SUBJECT: Closure plan for Guadalupe Operating Yates Federal Tank Battery
O 6-20s-21e – API #30-015-01027

Reference: Yates Federal 009 O-6-20s-27e 30-015-01027

Drawing of Site and Contaminated Area

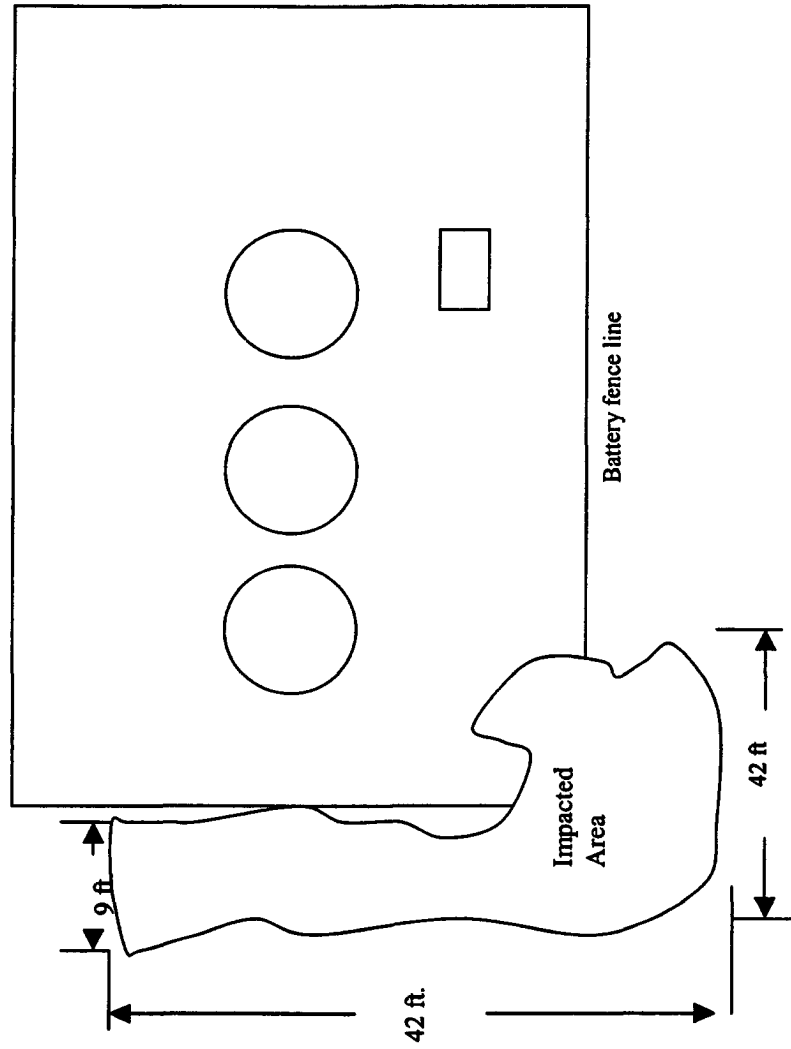
The NMOCD District 2 office (OCD) is in receipt of a brief remediation work plan submitted by your agent, Allstate Environmental Services, proposing remediation of contaminants at the above referenced well site. The work plan does not include the proposed disposition of contaminated materials, and proposes a Remediation Level for chloride contamination of 2000 ppm. The following stipulations apply to this proposal/project:

1. WQCC guidelines dictate that ground water may not be impacted at levels above 250 mg/L. Ground water information indicate this well site is in a possible shallow ground water area. Proposed remediation levels for chlorides of 2000 ppm is not acceptable.
2. Contaminated materials are to be hauled to an OCD approved disposal facility or an alternate proposal submitted.
3. The well site is situated in Range 27E, not in Range 21E as indicated on work plan proposal.
4. Notify the OCD 24 hours prior to commencement of remediation activities.
5. Notify the OCD 24 hours prior to obtaining samples where analysis of samples is to be presented to the OCD.
6. Work on project is to commence no later than November 1, 2005.
7. A final report is to be submitted to OCD upon satisfactory completion of project.
